AGENDA

President and Board of Trustees
Village of Arlington Heights

March 19, 2018

- A. Sigwalt Apartments/CA Ventures - 45 S. Chestnut Ave. -
PC#17-016
PUD, Preliminary& Final Plat of Subdivision, Rezoning, Variations

C6.2

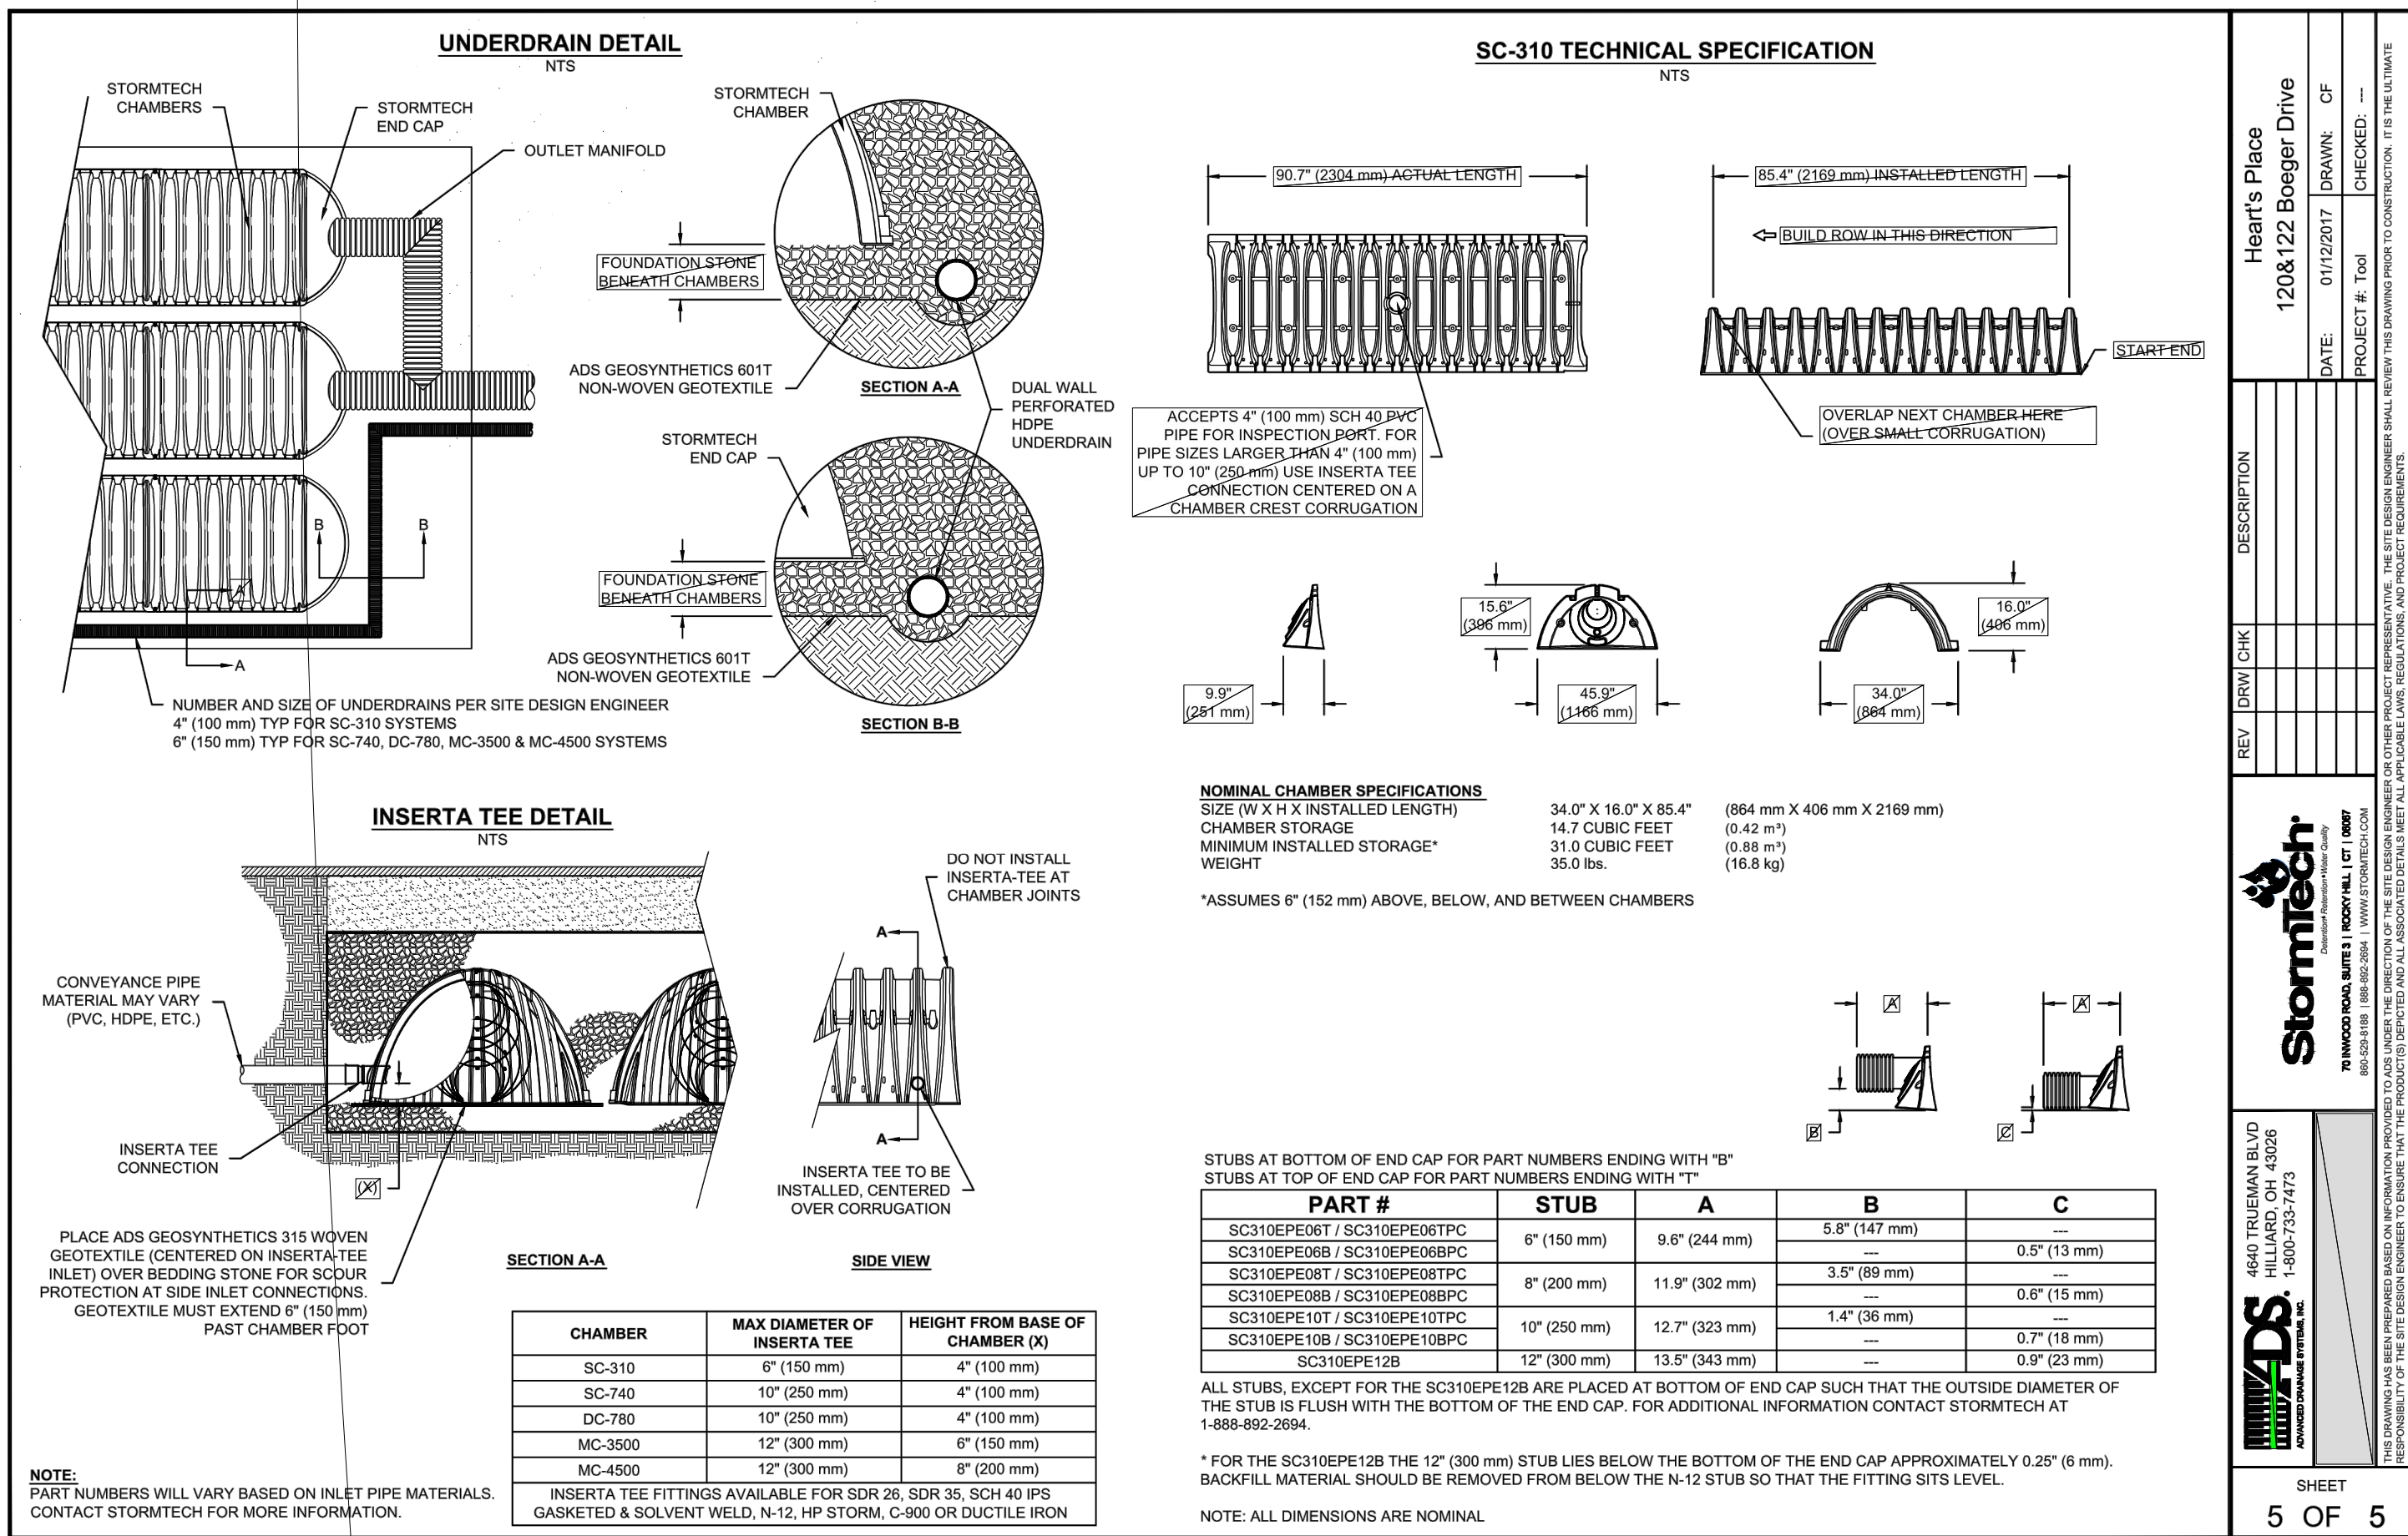
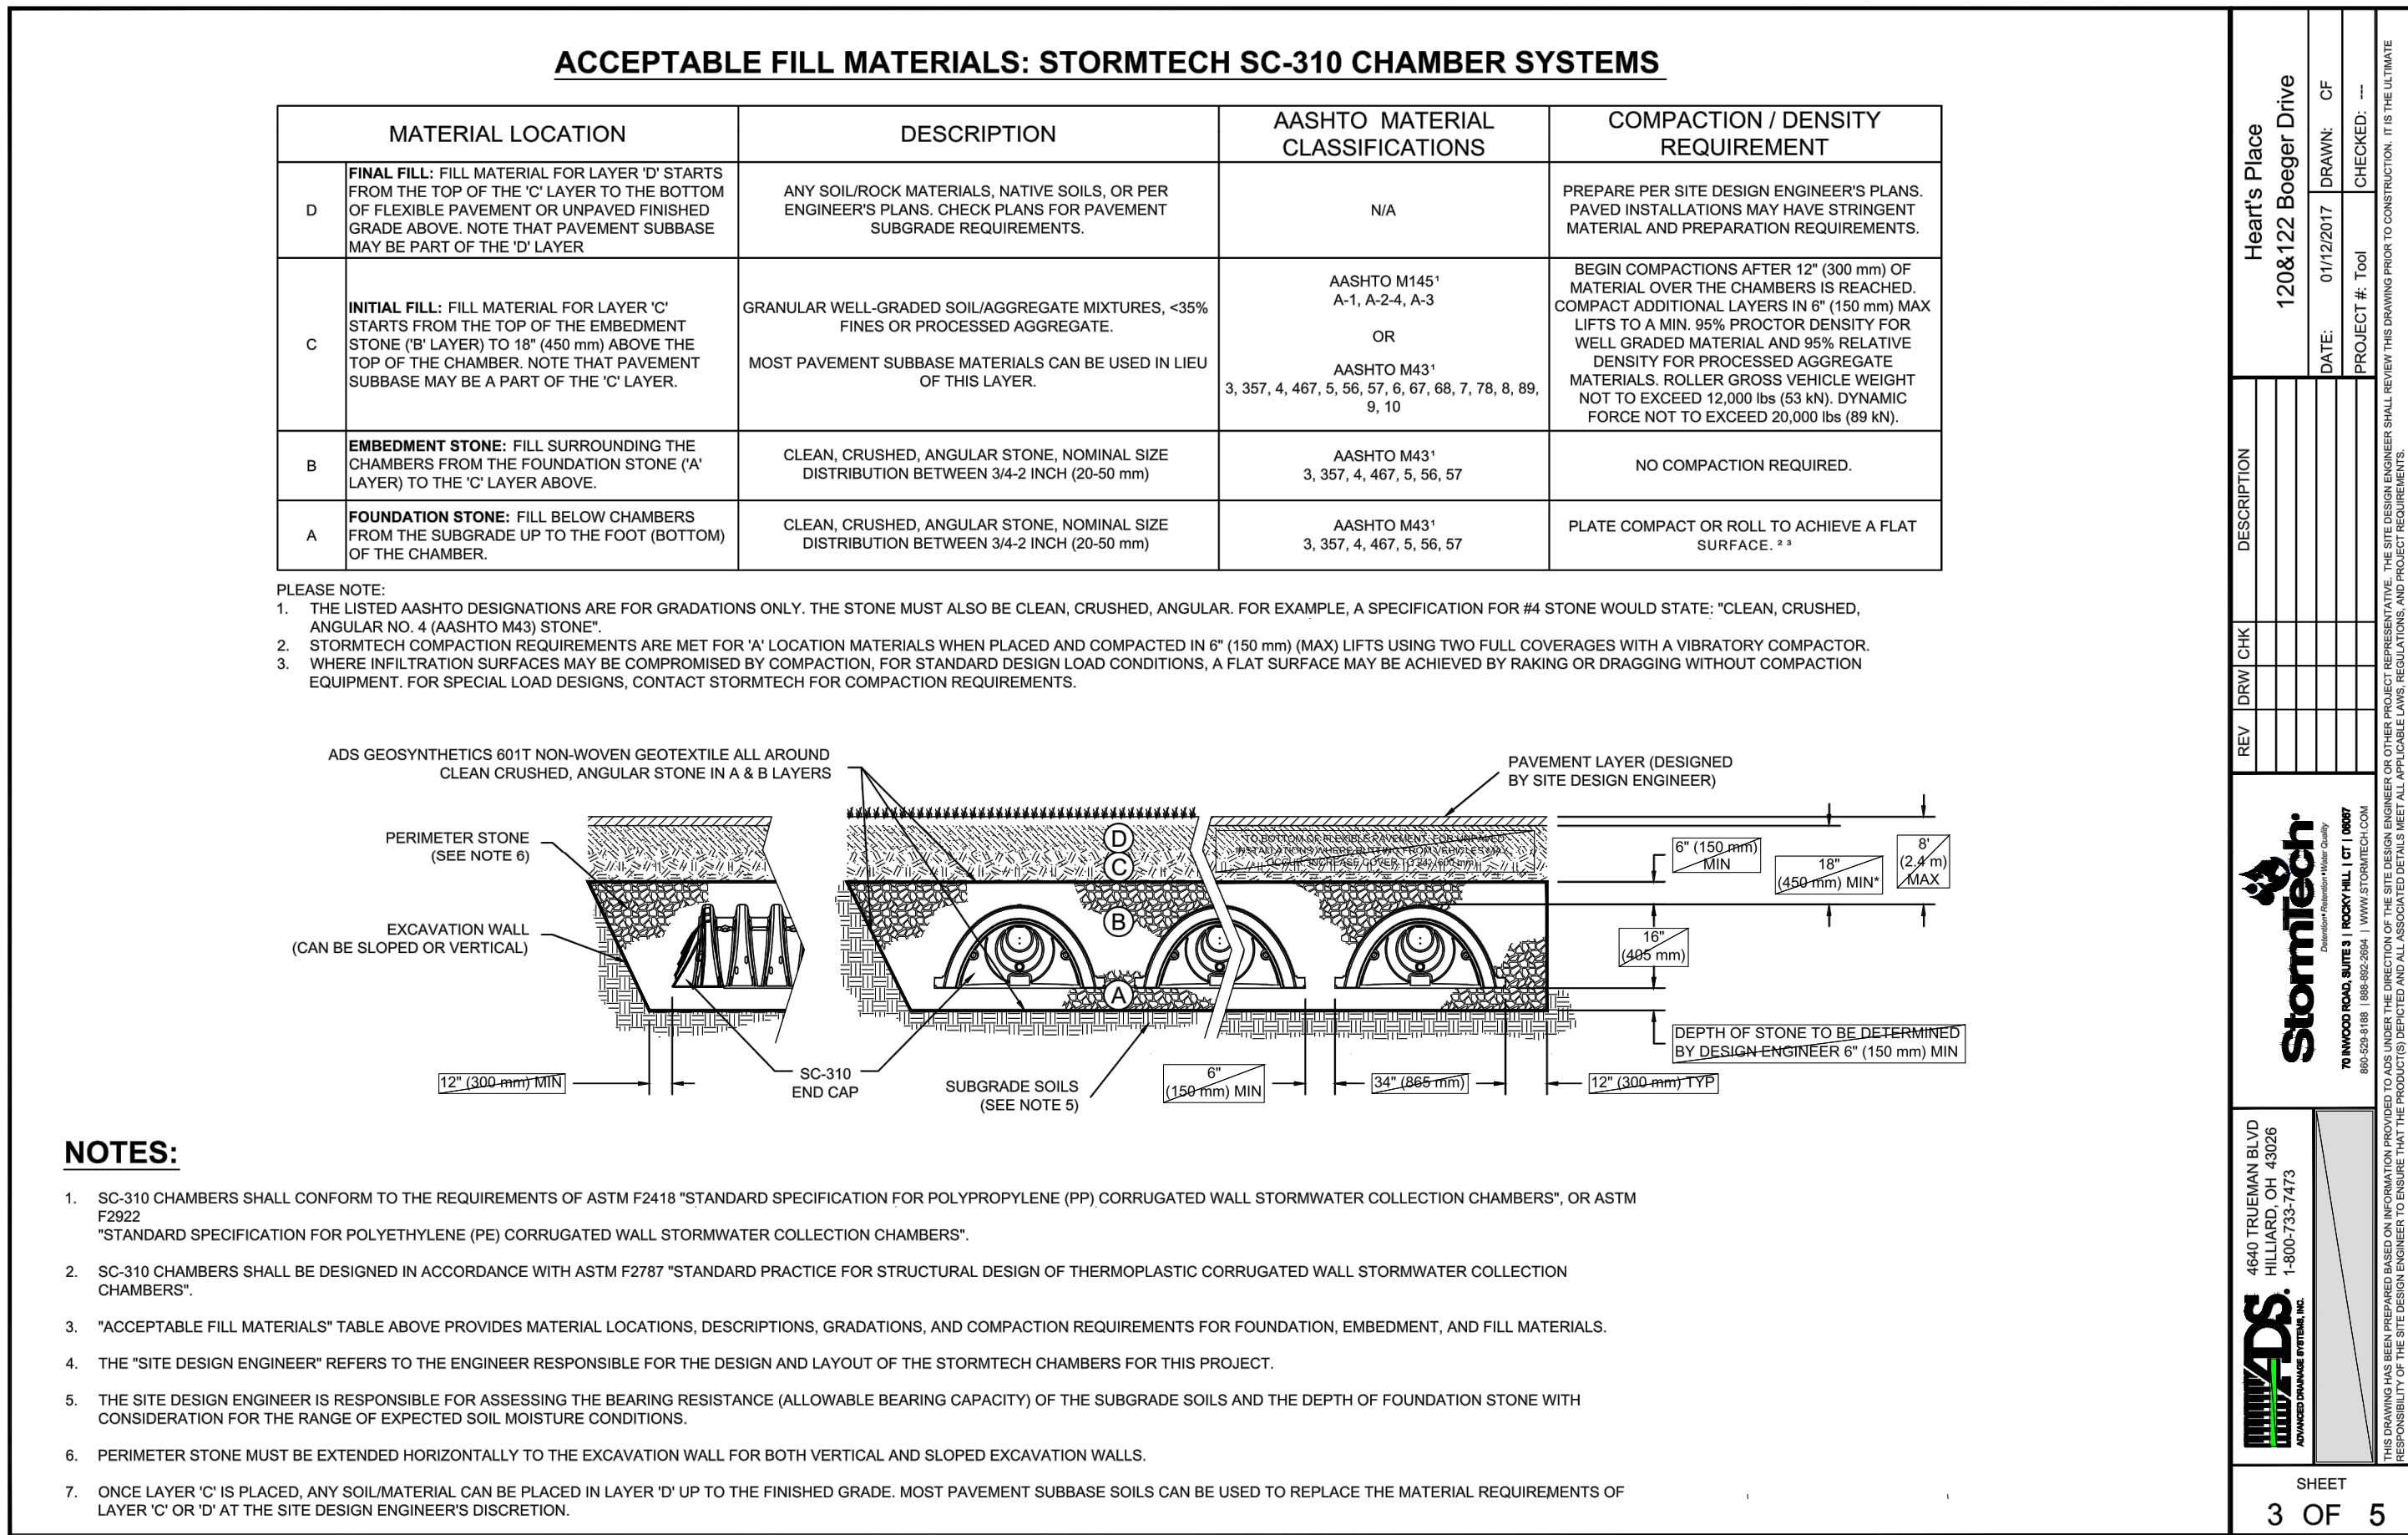
17. Provide cut sheets or plan details from the manufacturer for the proposed StormTech system, including design loading criteria and proposed volume.
18. Sheet CX-1.1: Village Code requires fire hydrants at a maximum spacing of 330'. Add a fire hydrant somewhere between Station 1+50 and Station 2+75 on the new water main extension.

RESPONSE: Per coordination with the Engineering Departments, the details were previously provided and accepted on the Building Permit Submittal plans. The details can be seen on C6.2 & C6.3
